5 August 2010

Our Ref: E6102.1\_It

**RE: Issues raised by Department of Planning and Tweed Shire Council relating to the proposed tourist resort at Casuarina Way, South Kingscliff**

**FIGURE 1**

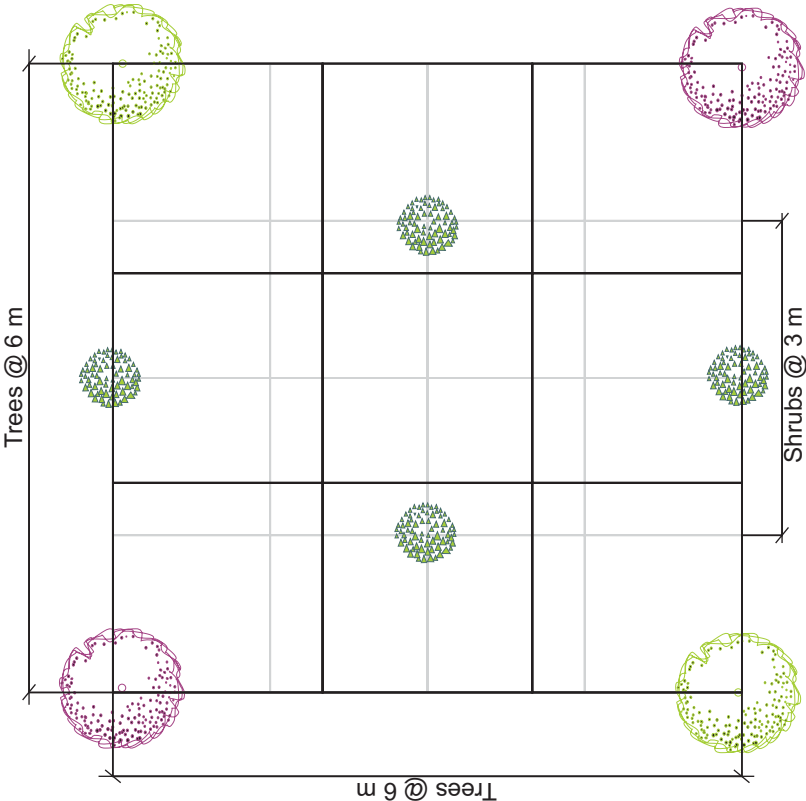
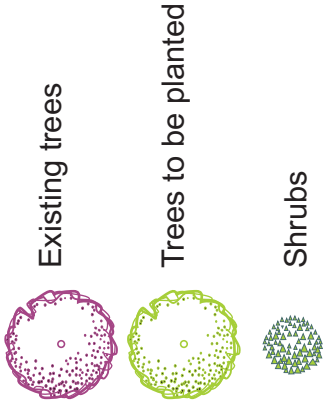
3. revegetation with Littoral rainforest species. Littoral rainforest species are considered to be fire resistant. A list of suitable species and a recommended planting plan is depicted in **FIGURE 1**;
4. maintenance of low fuel loads on the ground will be achieved by regular slashing of the groundcovers and removal of fallen timber.
